# RE-909

# RE-909 Additional Advisories:

v0.1F

### 3 - SWITCHBOARD PCB ERROR

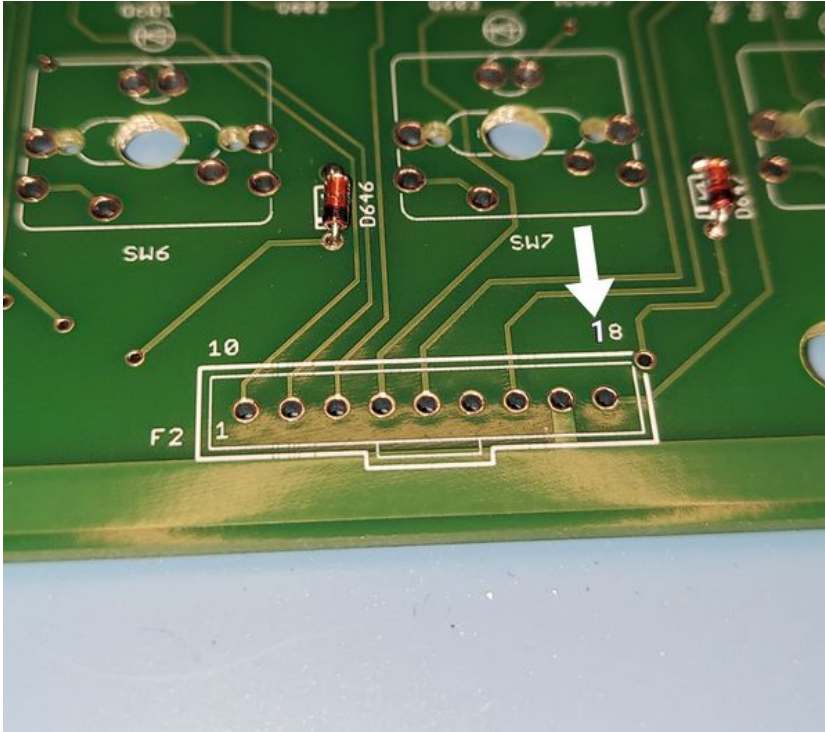
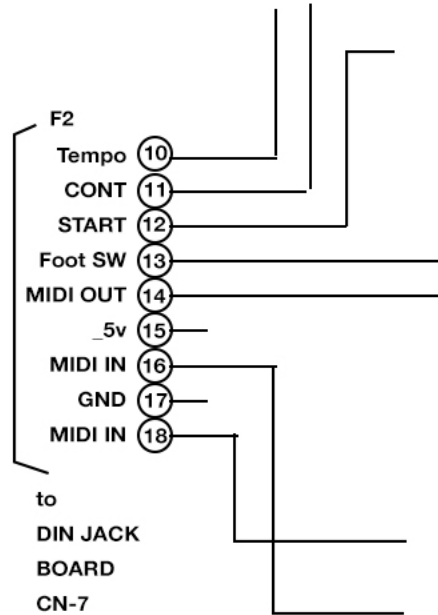
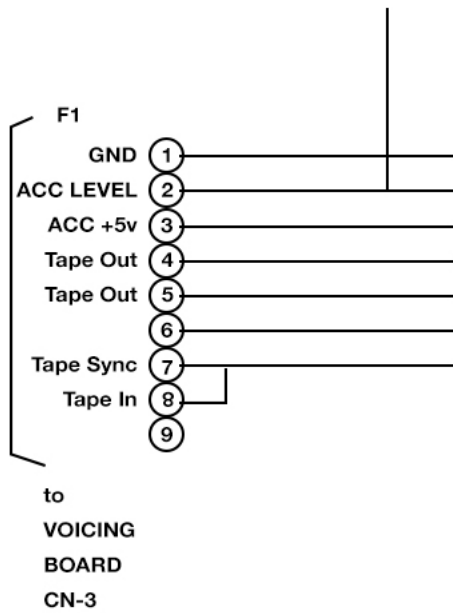
The pin numbers of the switchboard connectors were incorrect on the initial run. See the pin out/destination diagram from the service notes (above) and be sure of your pins and destinations on your switch board (below). Check twice, solder once.

## 3A - RE-909 Cabling Guide

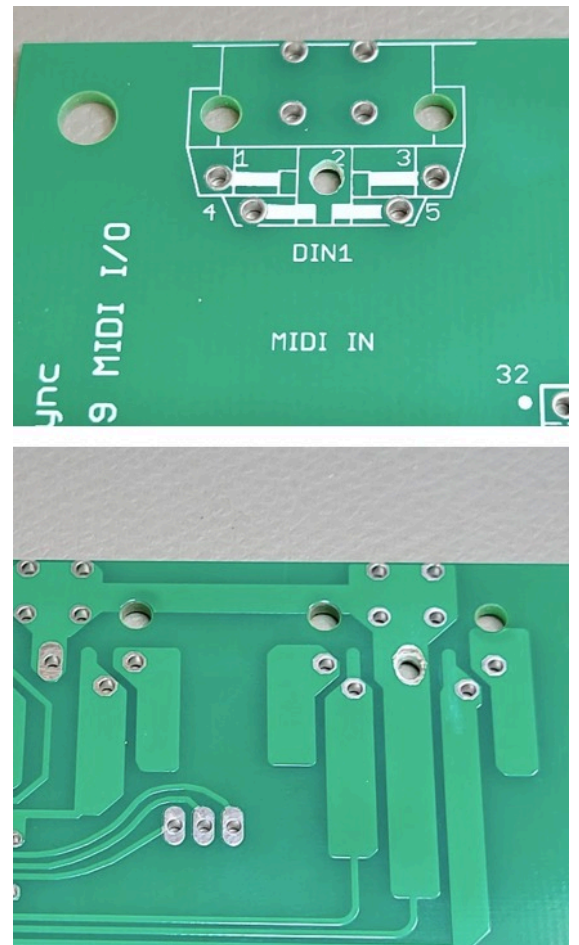
|\_\_ **Disconnect for safety PSU**

## 5 - SD ENVELOPE FIX

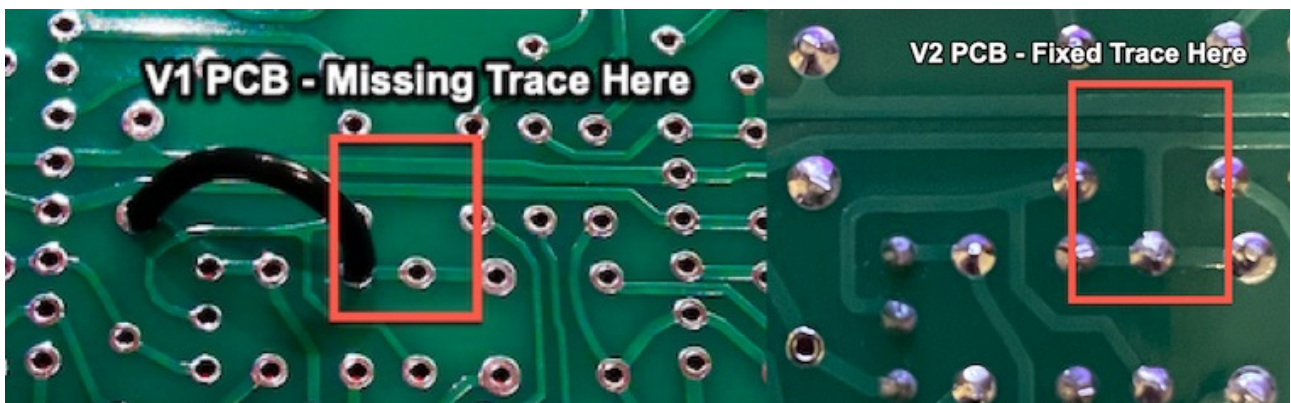
RE-909 service advisory 15-12-20

We found a minor error in the snare drum that didn't come up in testing. Its a simple fix with a single patch wire, please download v.1.7 build documentation for details.

Fixed in voice boards V2
